## **Accessibility Recommendations for the McBride Train Station**

Apex Access Consultants

# Village of McBride Historic Train Station

WASHROOMS – Urinal 2

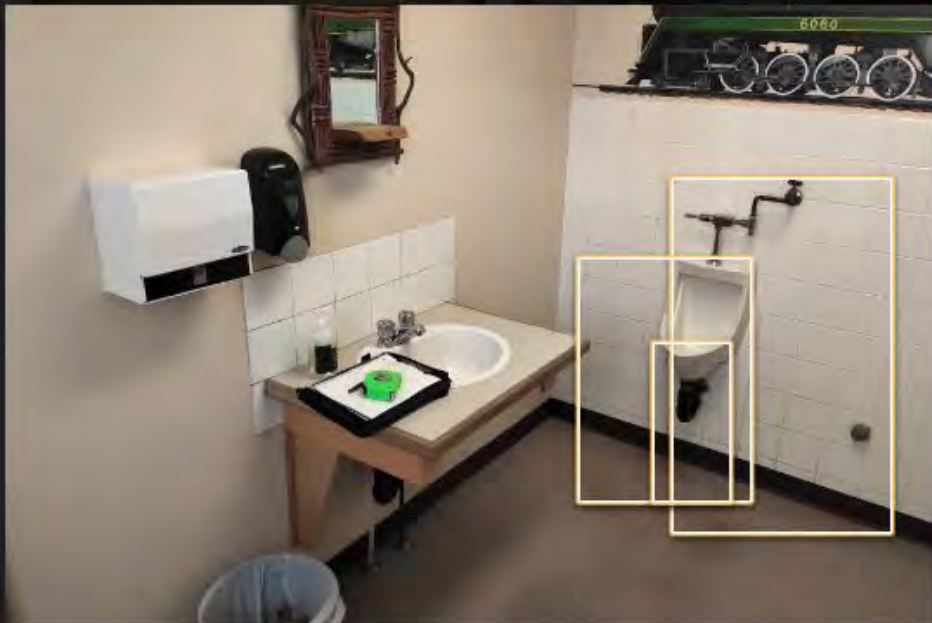
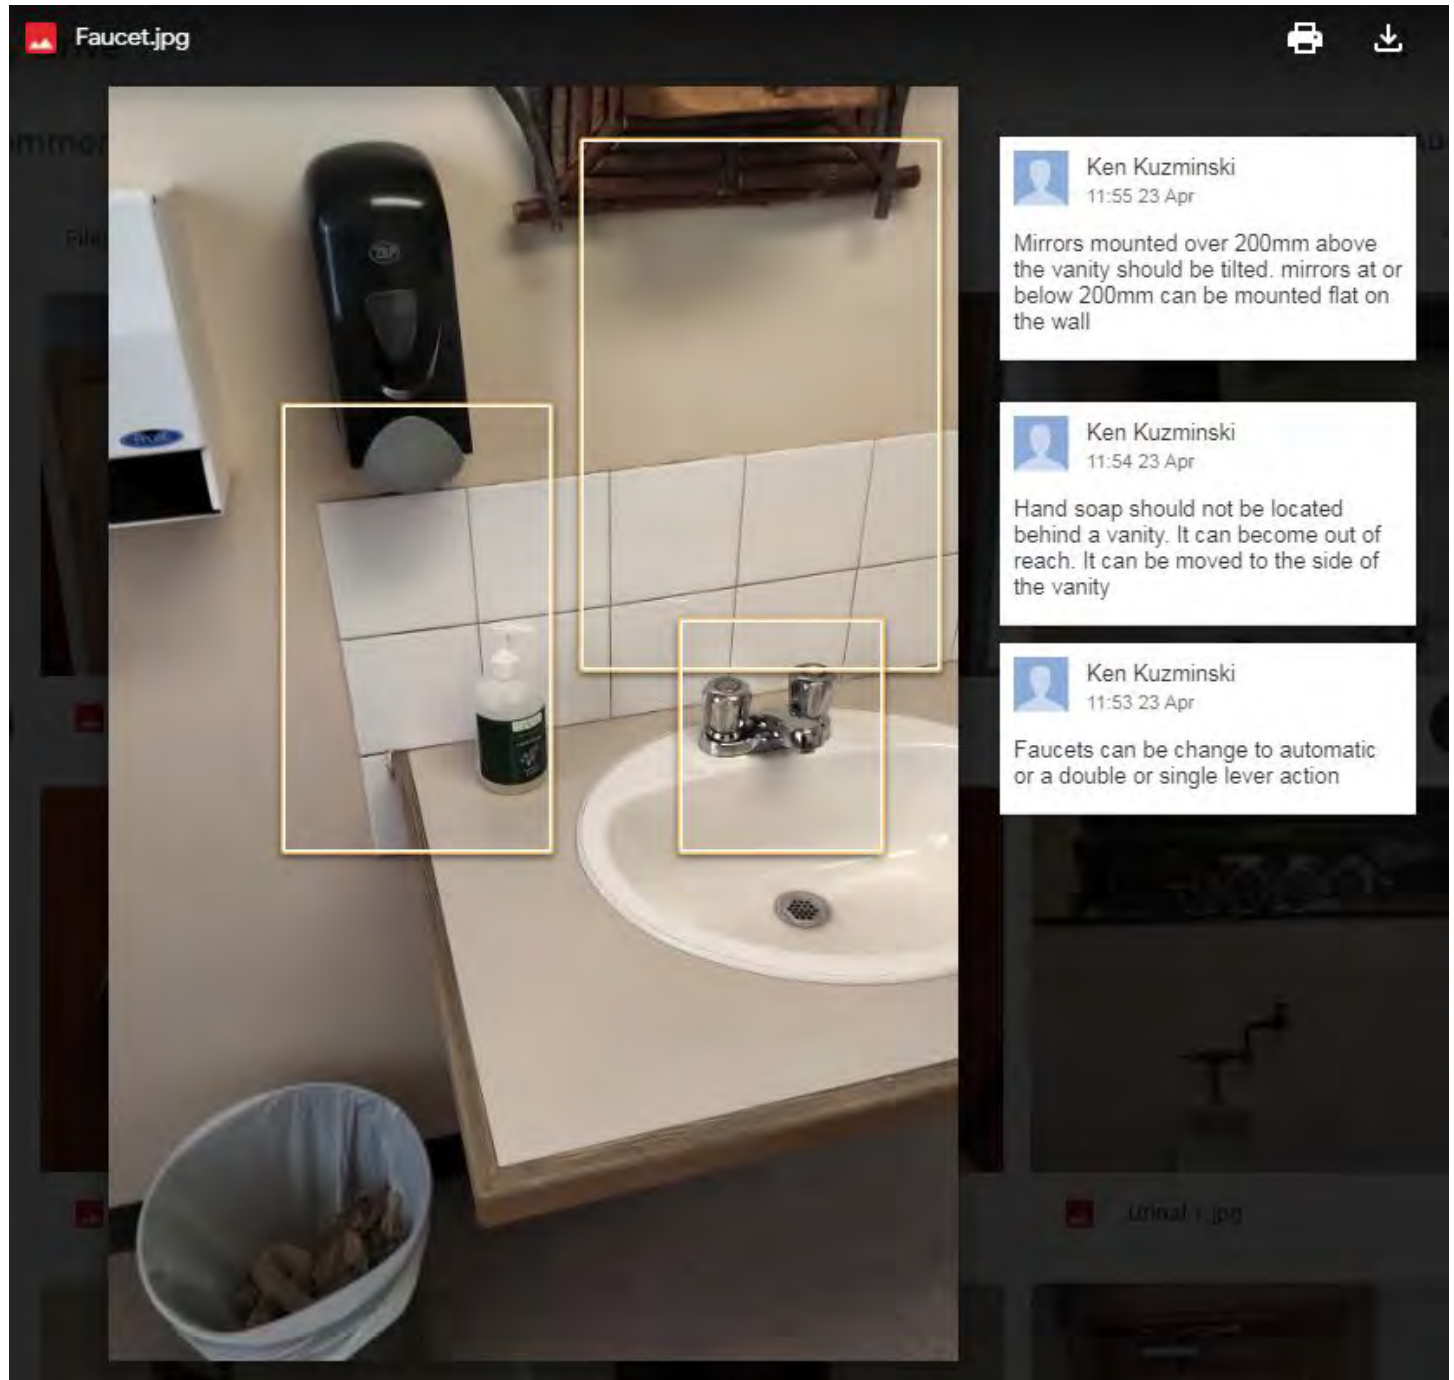
Urinal is the same colour as the surrounding wall. Contrasting colour is recommended

Clearance from the vanity should be maintained

Basin Height is above the recommended height

RESTAURANT – Seating

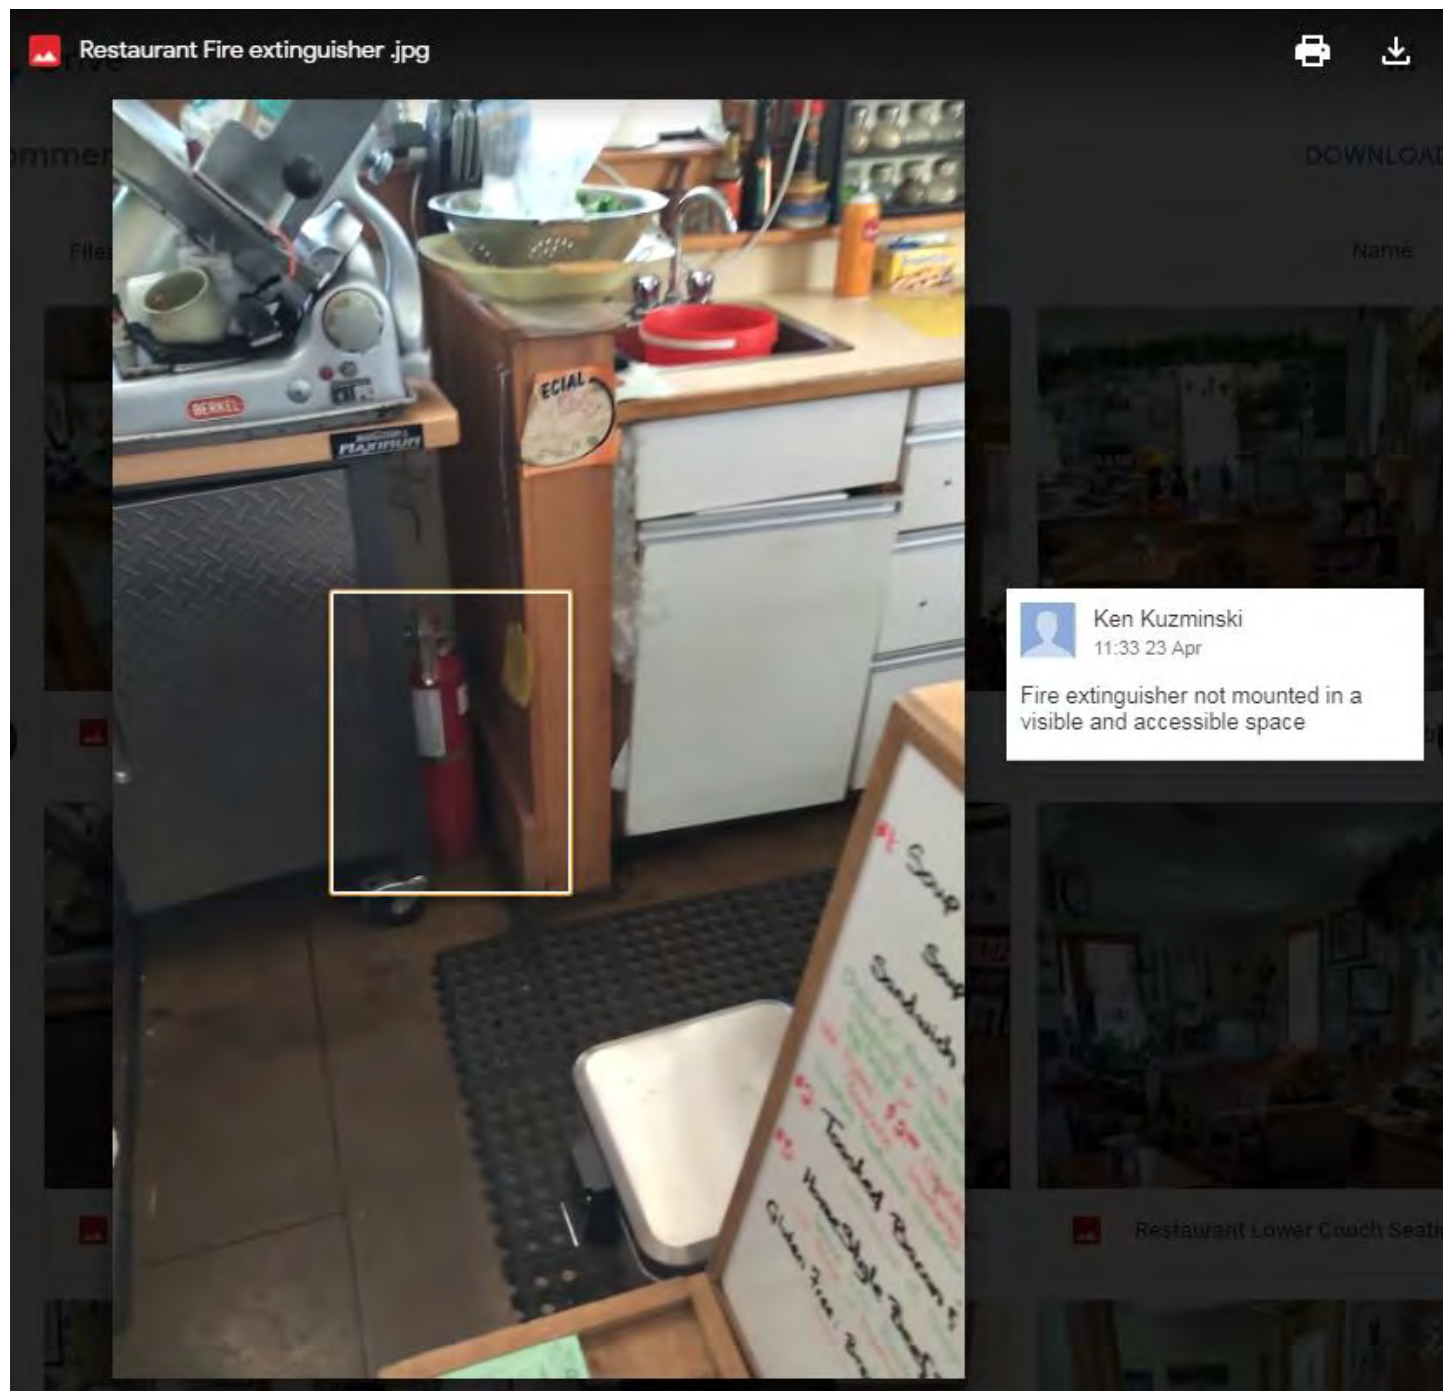
Ken Kuzminski  
11:40 23 Apr  
Cashier is partially visible but can get lost within the other hanging items

Ken Kuzminski  
11:39 23 Apr  
Order Sign is not visible so it causes confusion to how to proceed in the restaurant.

Ken Kuzminski  
11:41 23 Apr  
Glasses are within reach but can become unstable if they are stacked to high and someone in a wheelchair is reaching for them

Ken Kuzminski  
11:37 23 Apr  
Condiments are accessible

Ken Kuzminski  
11:38 23 Apr  
Added items on the floor can be a barrier
